ADDENDUM NO. 3

1904 / KVCC WHITNEY WING RENOVATIONS

Lewis + Malm Architecture

30JAN2020

ELECTRICAL DEMOLITION PLAN
SCALE: 1/8" = 1'-0"

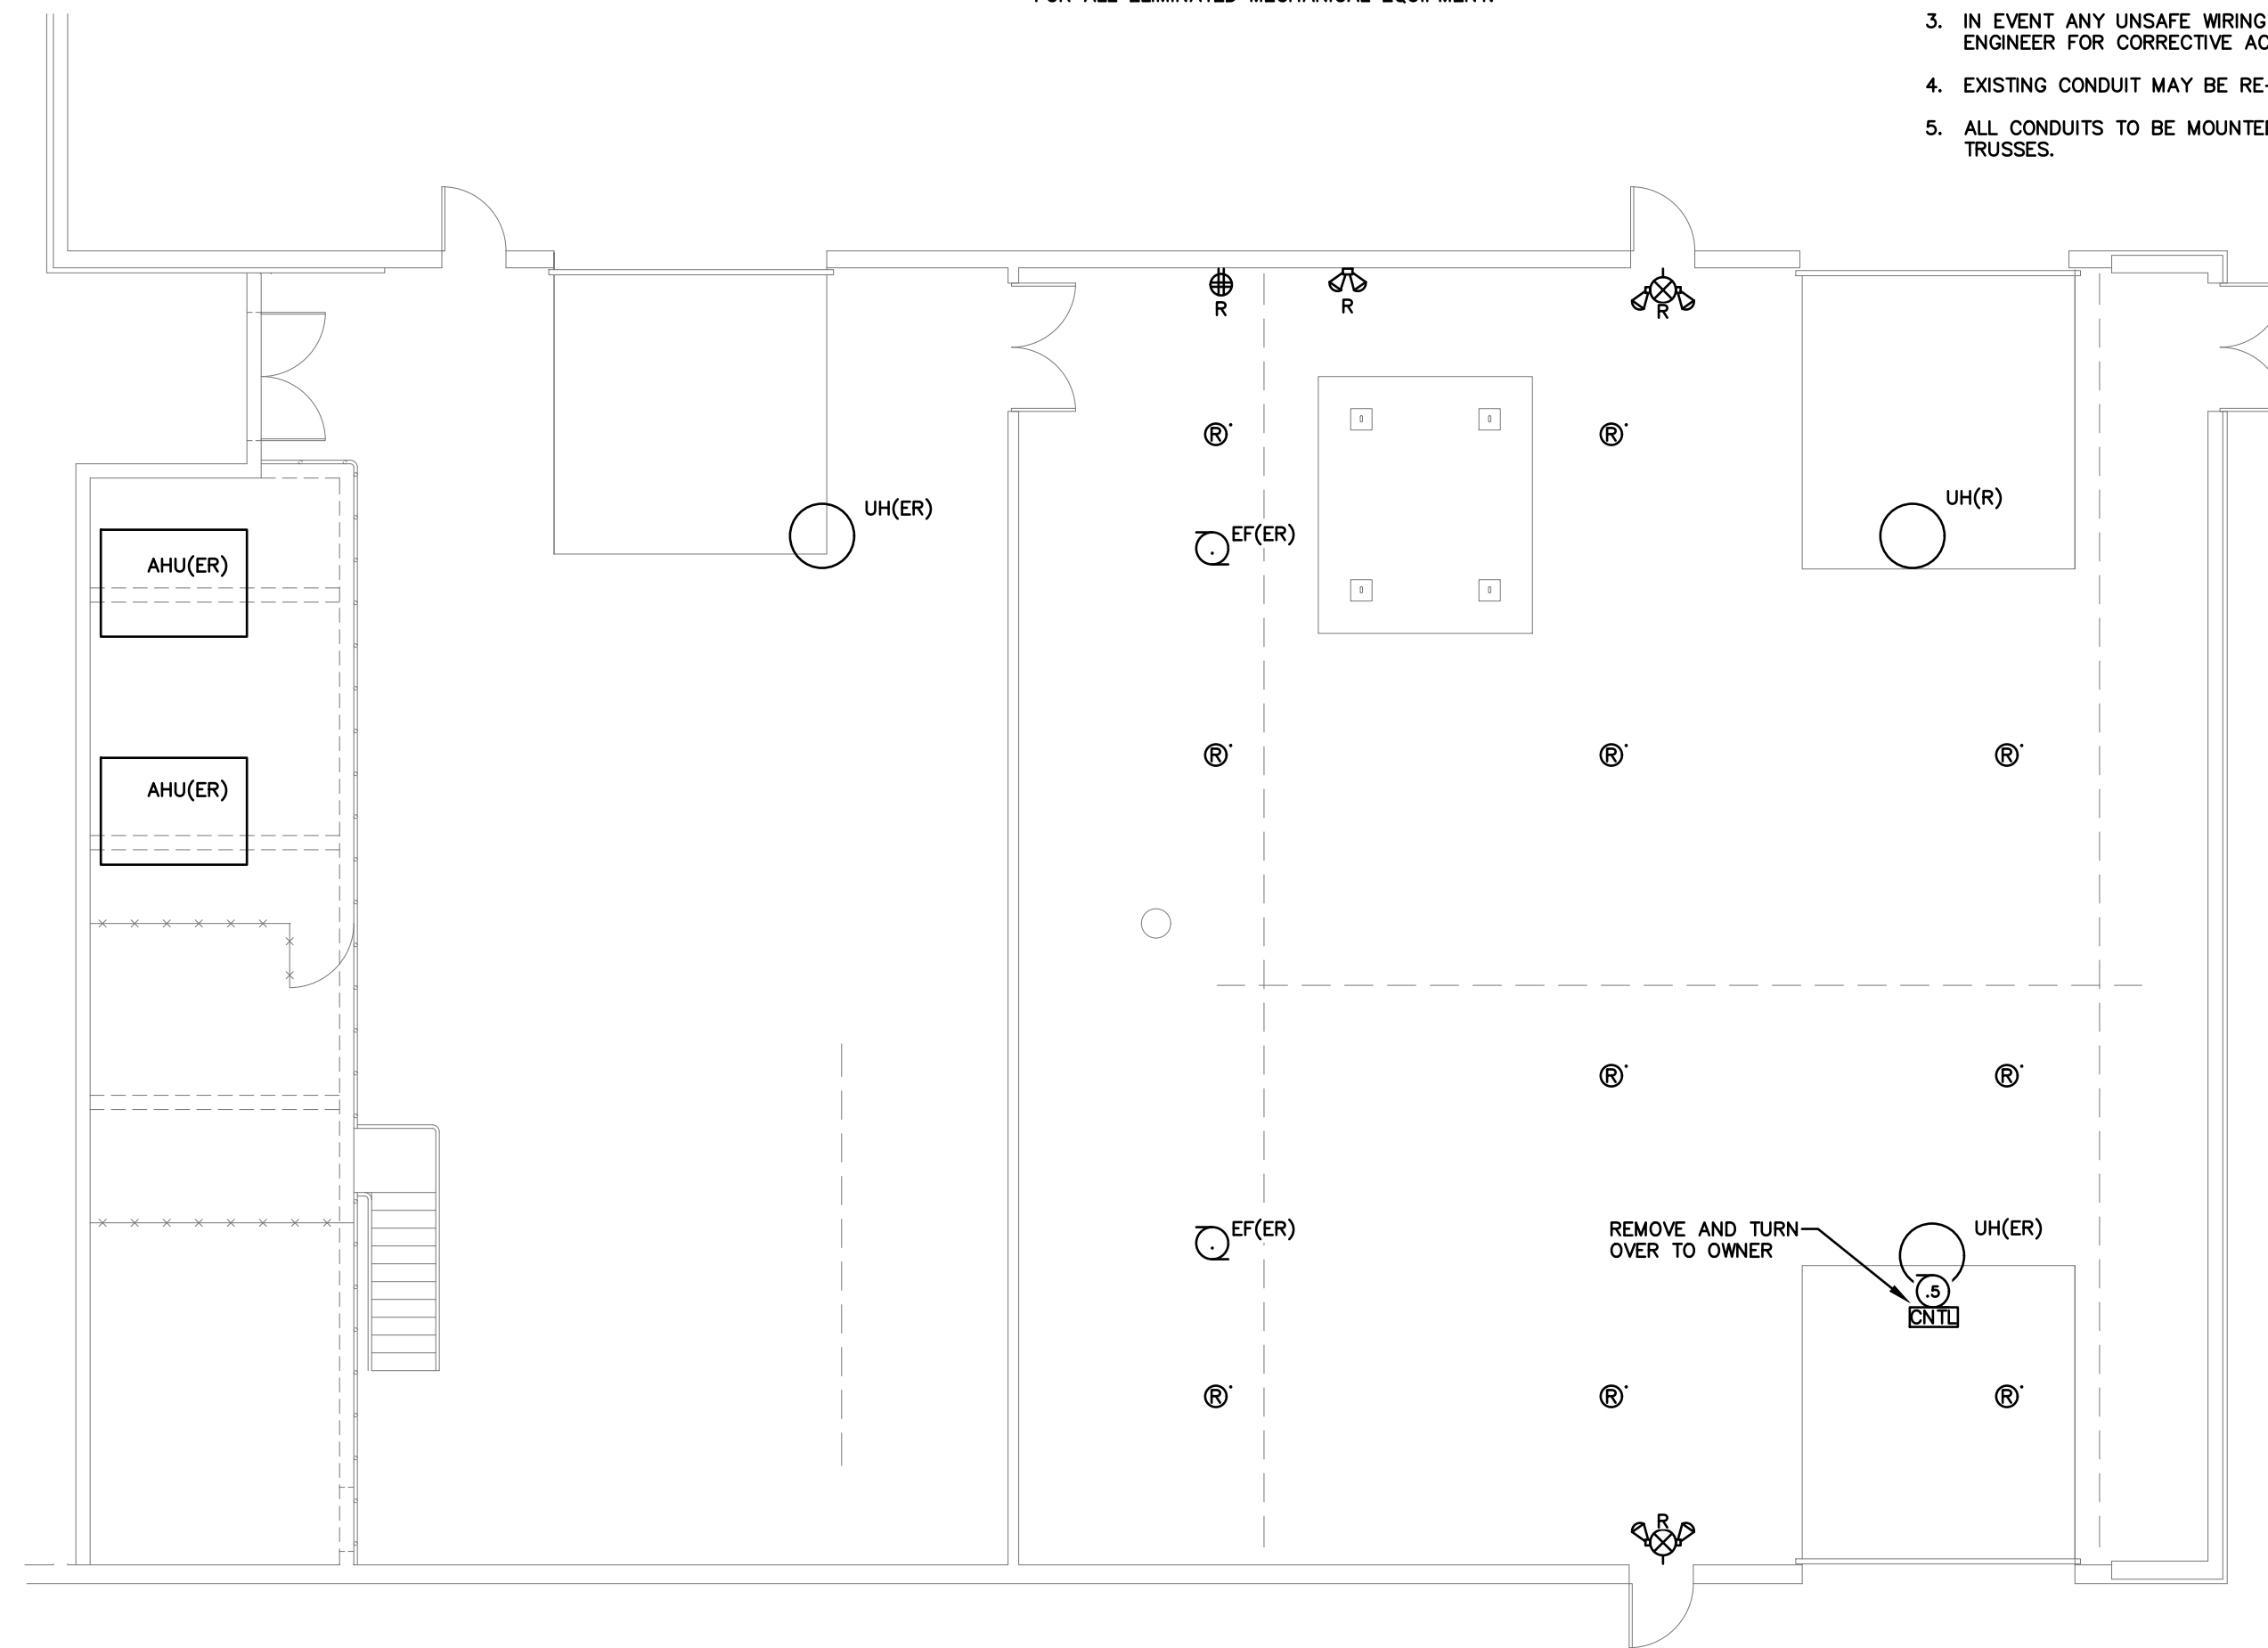
QUESTION 3) There is an 'electrical demolition plan' for the new welding lab (see electrical drawing E1. However, there is no electrical demolition plan for the existing welding shop. Is the intent, within the scope of this project, to completely demolish all electrical branch circuits, welding circuits, lighting, lighting circuits, etc. within the existing welding shop space, after the new welding shop is completed?

RESPONSE to Q3: No. The design intent is to keep the Old Welding lab in operation UNTIL after the new one is installed. The Owner has not determined what they will do with the space in the future. The design intent is that when the New Welding-Lab construction is completed and goes online, the Existing Welding-Lab will no longer function as a Welding-Lab.

PROPOSED POWER PLAN
SCALE: 1/8" = 1'-0"

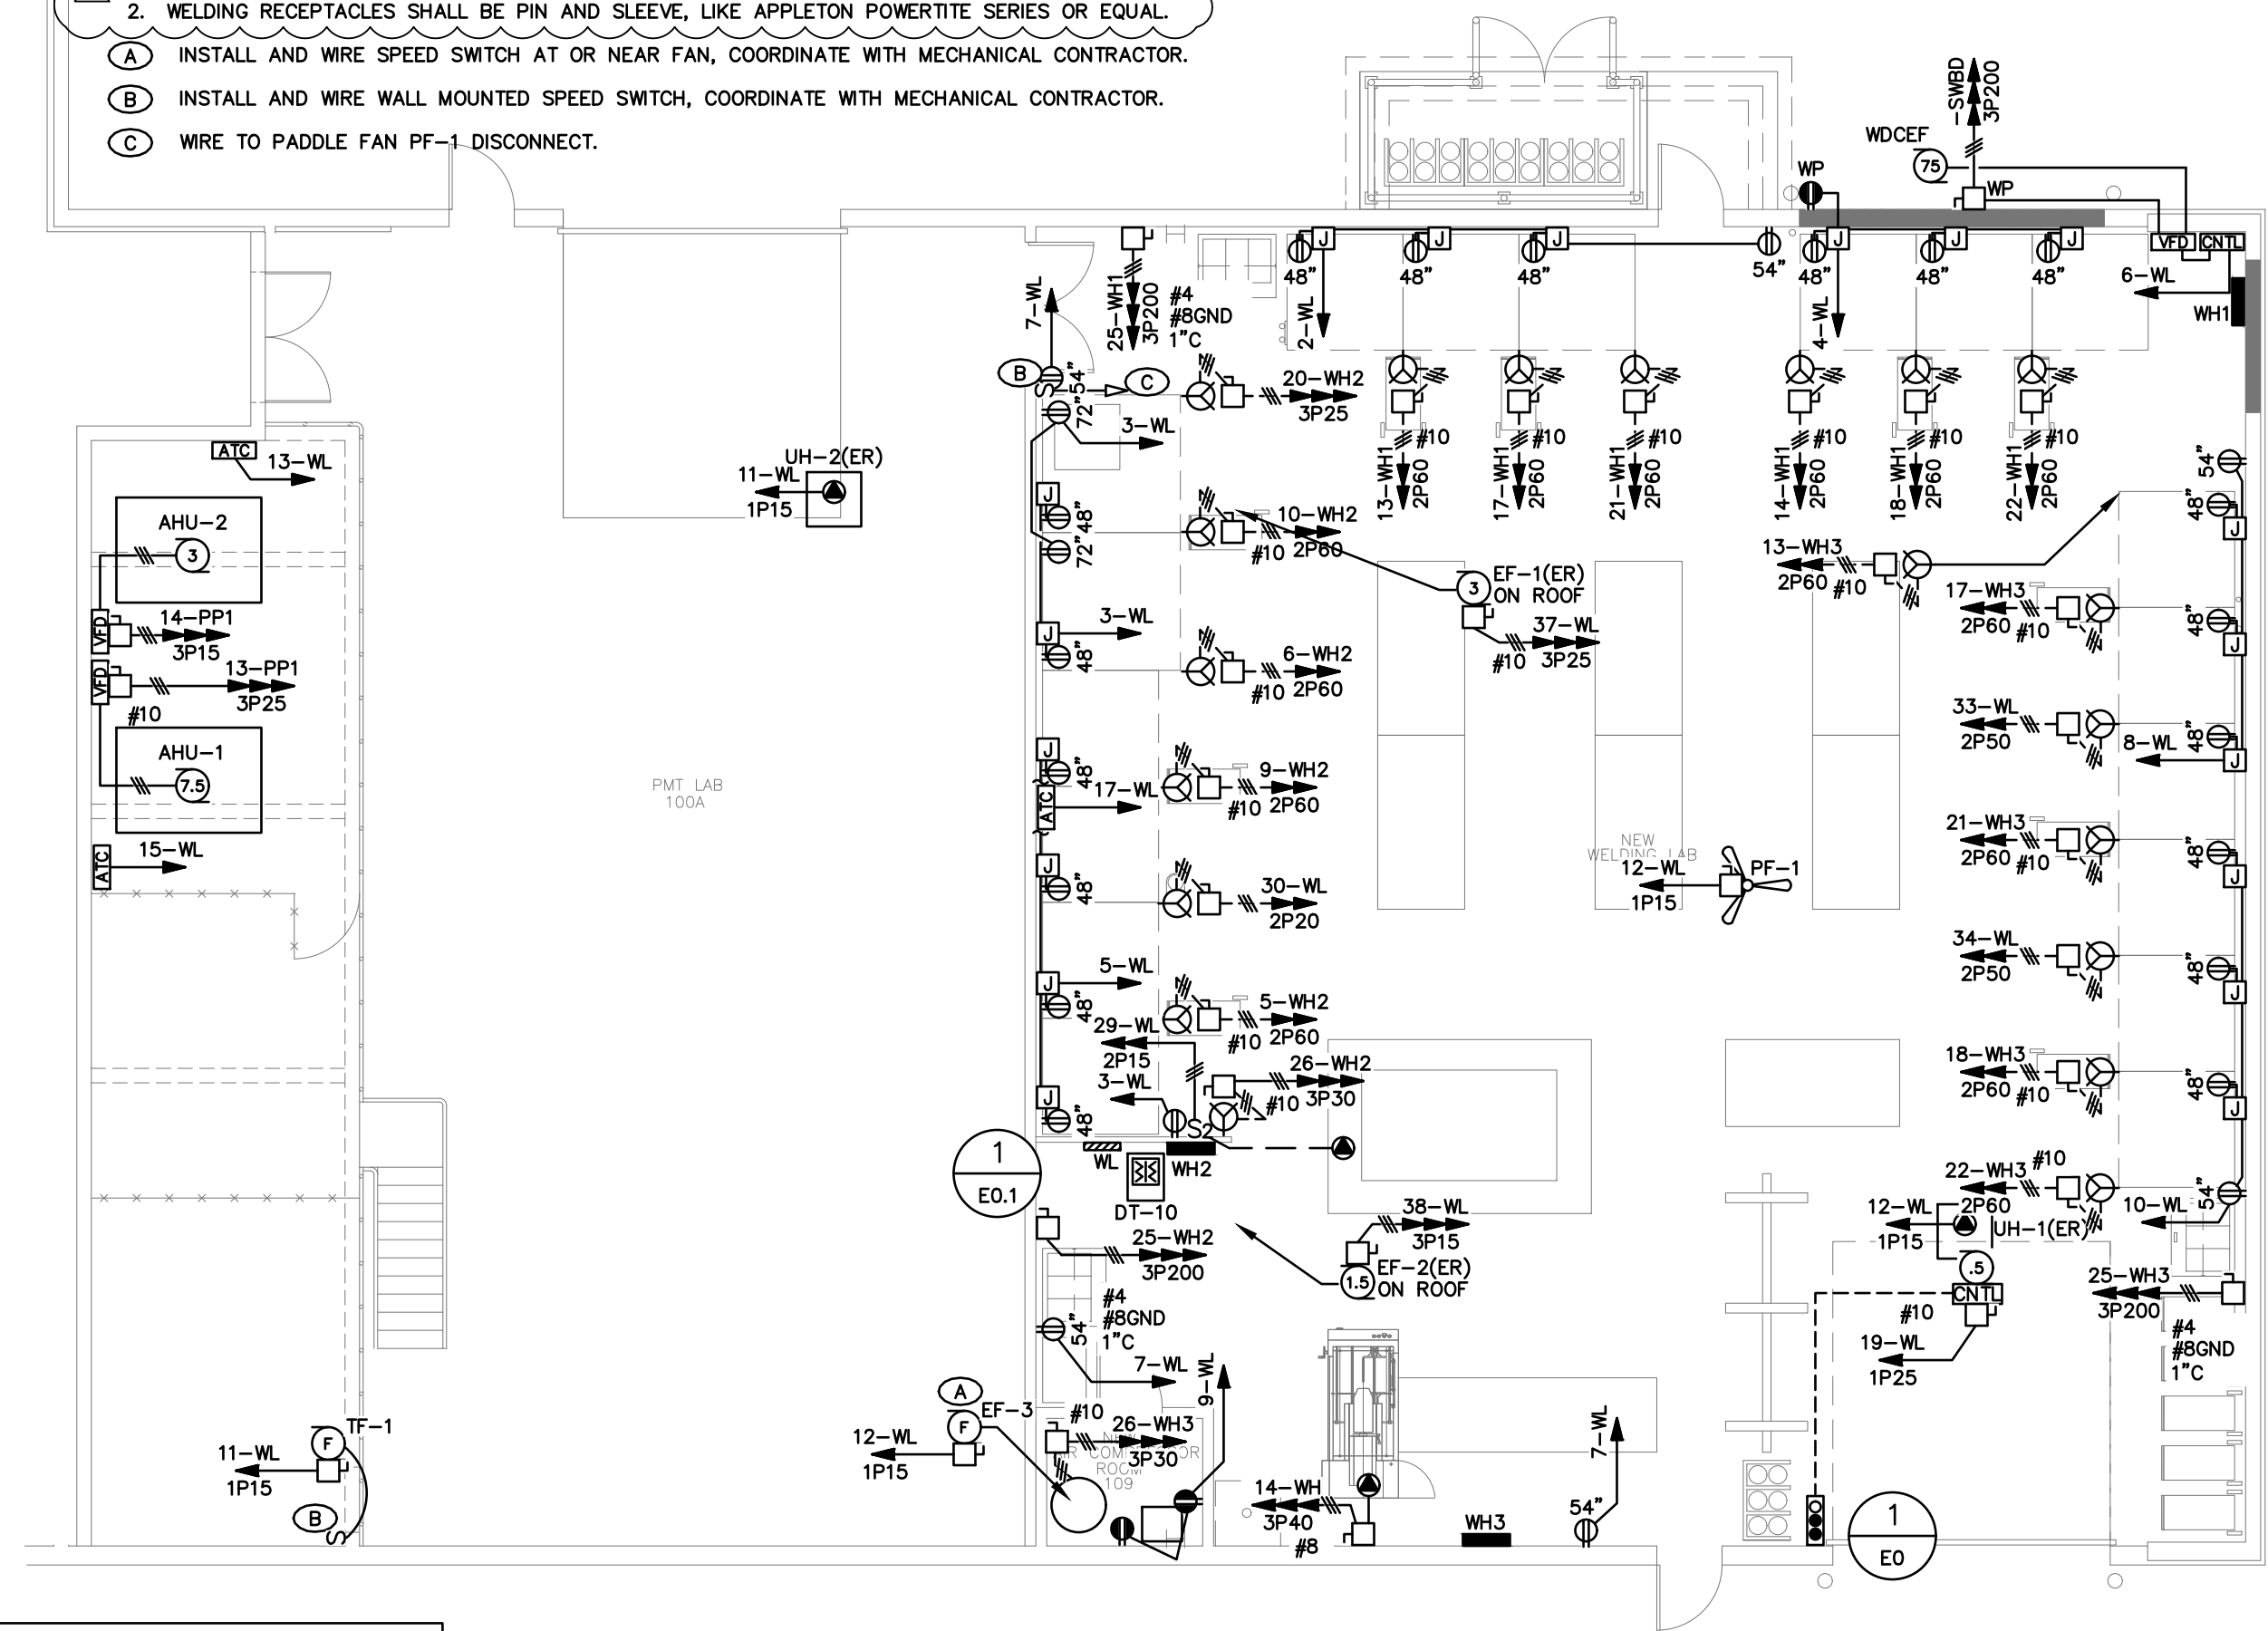
QUESTION 2) Please provide a product specification intent, for the welding outlet receptacles depicted on the 'proposed power plan' for the new welding lab. Please see electrical drawing E1, and also depicted on the electrical symbols legend, drawing E0, as "208 to 480V welder outlet". The symbol on the legend has a similar appearance to the Mercedes Benz logo (circle and peace sign).

RESPONSE TO Q2: On drawing E1 Power Notes: DELETE #1 text reading "Paint all Surface Conduit Powder Coat Black..." and ADD #2 text reading "The welding receptacles shall be pin and sleeve, provide Appleton Powertite Series or equal (See Drawing E1)".
